Re: L11-D067 Approved for Preliminary Plat - DRB # 1008926 (and Final)

Re: Francisco Lopez, Bridge/Eucariz Grading & Drainage Plan (L-11/D067)

Lot 316A, Unit 3, Town of Atrisco Grant Engineer's Stamp dated 09-21-12

Attachments: SPOTS Lots1\_2.jpg

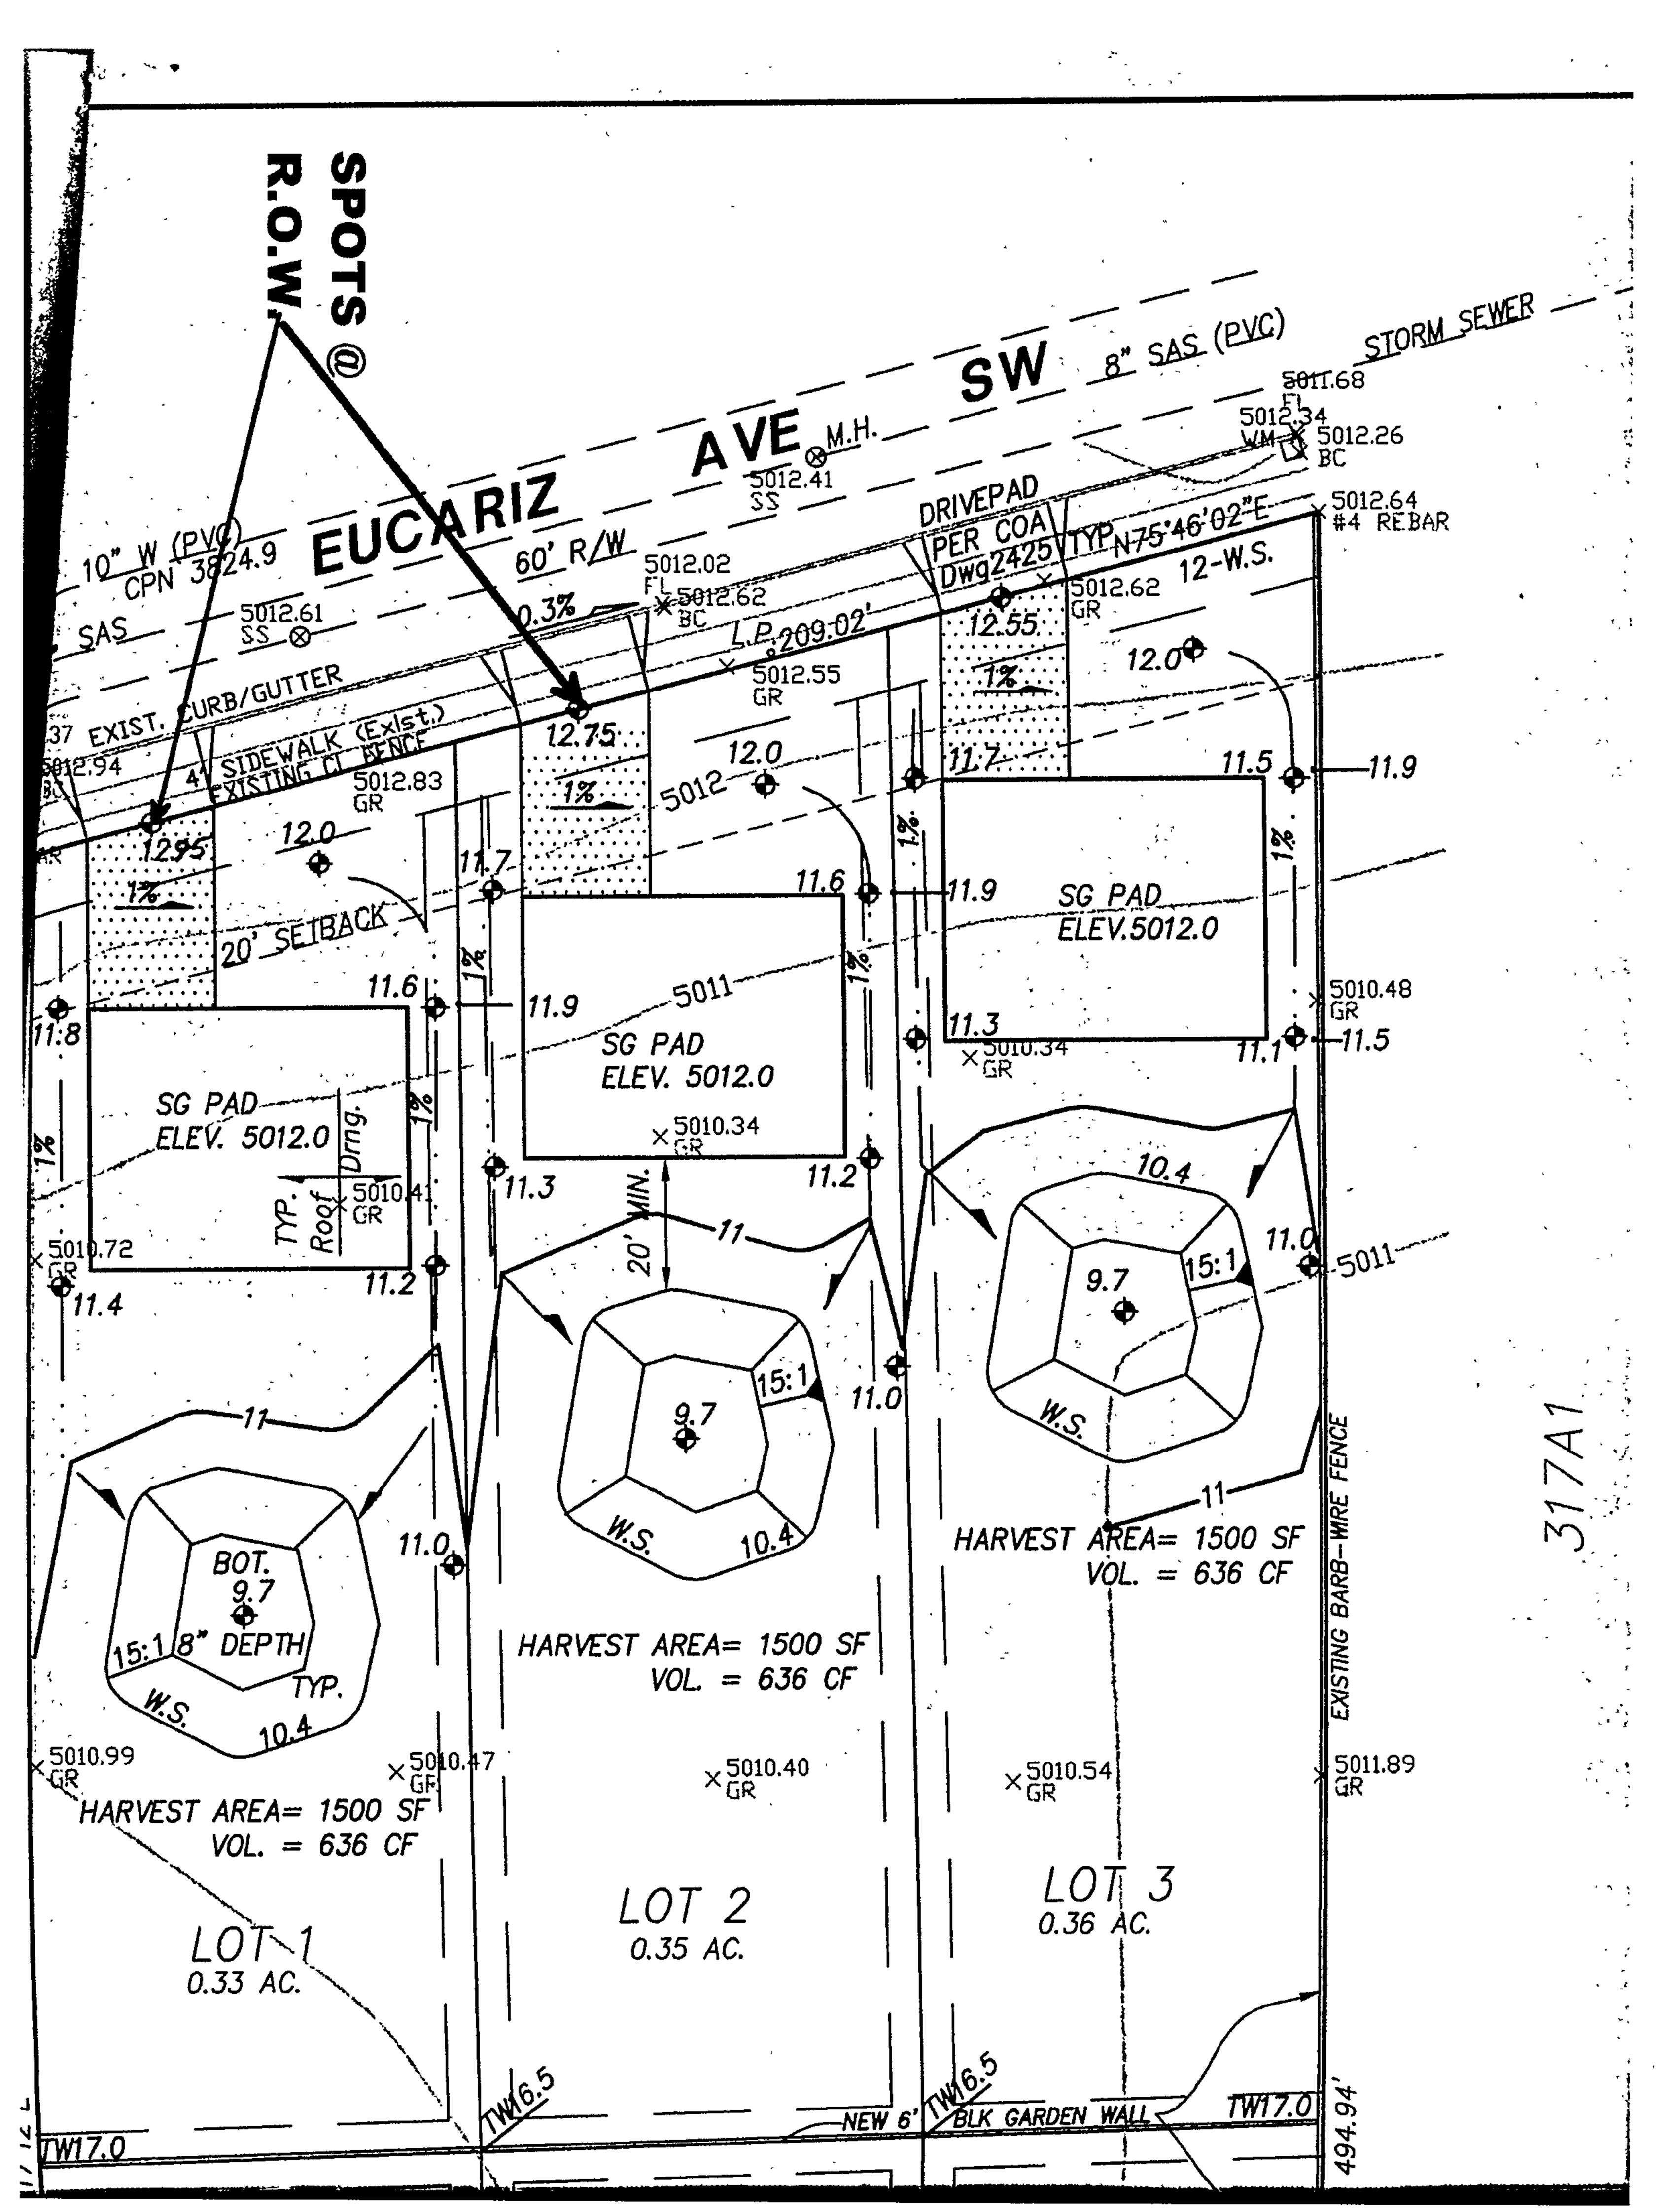
Final Plat and Grading Permit approvals will require the grade revisions on the north lot lines. Building Permit(s) will require certification of the grading, at least for any lot requesting BP. Please call or email if you have any questions.

Prior to Final Plat approval or Grading Permit, as you proposed in a subsequent email, the spot elevations on the north lot line for Lots 1 & 2 should be raised to match their respective top of curb elevation to ensure an adequate water block.

It is my understanding that this project goes before DRB next week for Final Plat. The **attached** shows that the "GRO" requested spots were added to the plan (one year ago! coincidently). Hopefully, no surprises next week.

@ the ROW - I raised two spots on Lots 1/2 to 12.95 and 12.75 respectively, on my original. Good catch, thx Phil

# GRADING & DRAINAGE PLAN

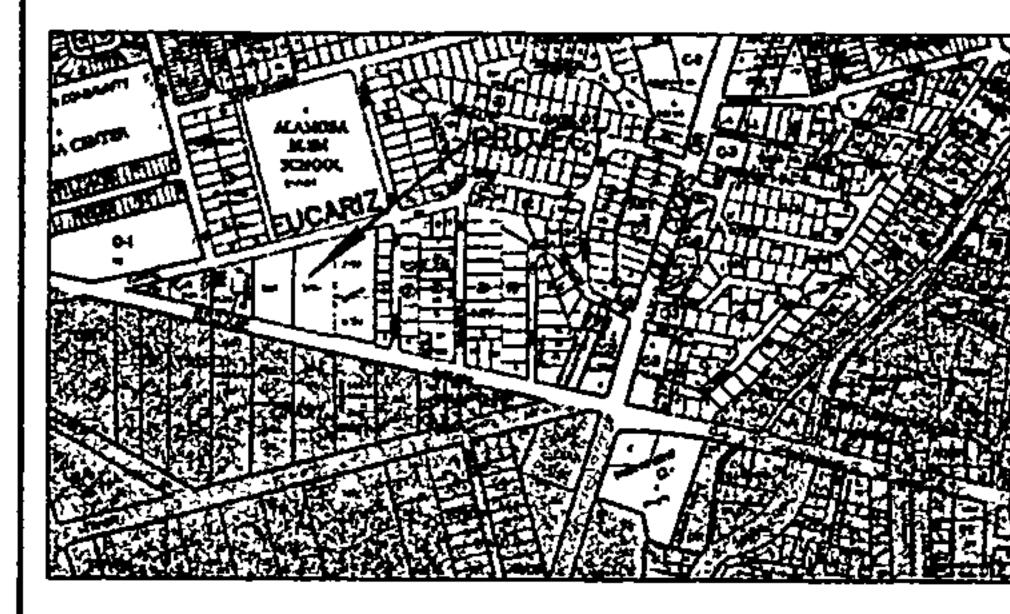
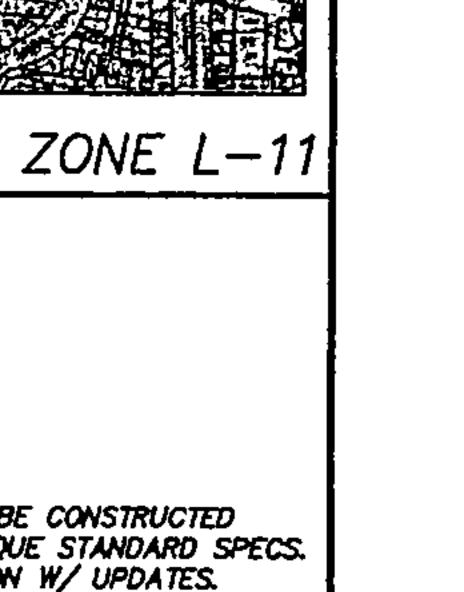
- 3. The small, 1' deep, backyard ponds are not acceptable, as they tend to get filled in over time, after the properties are occupied. Larger, shallower ponding areas should be shown, and located at the lowest area of each lot to allow all runoff to reach the pond. The whole-foot contours shown for the proposed ponds do not clearly show the pond size/limits of grading. Show a "water surface contour" to clarify the pond limits on your plan.
- 4. The front yard ponds along Eucariz need to be clarified, showing limits with "water surface contour" and overflow course.
- 5. The driveways from the northern lots to Eucariz are shown to drain to the NE, however spot elevations at R/W and on the pad indicate slope back toward the building pad. Clarify with spot elevations and swale arrows how this flow is routed.

- 6. Provide spot elevations and flow arrows on proposed swales indicating the direction of all flows to ponds and exiting the site.
- 7. Provide spot elevations around the four corners of the house pads on all lots to clarify drainage. Show how revised grades on this site match existing grades at the eastern property line, and where flows cross that boundary.

- Please show the depressed backyard ponding areas on the grading plan.
- Provide pond calculations for each of the backyard ponds.
- Include all proposed contours on the plan.
- Various proposed swales do not have arrows indicating the direction of the flow. Will the proposed southeastern swale affect the existing structure on adjacent Lot 317A2?
- It appears the swales along the northern property line also direct flow east to Lot 317A1.

- Lots 2 and 5 are not labeled on the plan.
- Provide additional spot elevations around the four corners of the house pads on all lots as you have done for Lot 6.
- Lots 1 and 4 show the roofs pitching to the east and west, is this typical for the remaining homes?

• Top-of-wall elevations are needed for the proposed block wall separating the northern and southern lots. Please include a detail of this wall in the grading plan.

- The existing contours shown on the plan should be carried out another 20 feet from the property lines.
- Grades and pad elevations on the Bridge side should anticipate future C&G and sidewalk improvements, which will result in higher grades along the southern property line.

- 1. Concur -plse see verbiage revised in latter part of text-report regarding retention / "first 1/2-inch". Cross-lot drainage is minimized/eliminated. Additionally, garden Wall is added to east bdry.

- 2. Revised rear harvesting area calcs typical calced two ways two shapes.
- 3. Shallowed up ponds to 8 inch depth. Request to do so will help balance earth work. Reduced sideslopes to 15:1. Shifted two-ponds(5/6) per Gregs suggestion. Added water surface contours. Added overall new contours, spot elevations, etc.

- 4. Deleted entirely the front 'ponds' /depressed landscaping along Eucariz. All of this runoff will be conveyed positively to the rear harvesting areas. Sized for the first 1/2" storm.

- 5. Driveway concern is alleviated because of 4 above, and new spots, swales + transverse flow direction revised on drivepad itself.
- 6. Comply added spots etc directing to harvesting areas / exiting the site.

- 7. Spots added to all four corners of pad
- 8. Concur plse see 1 7 above.
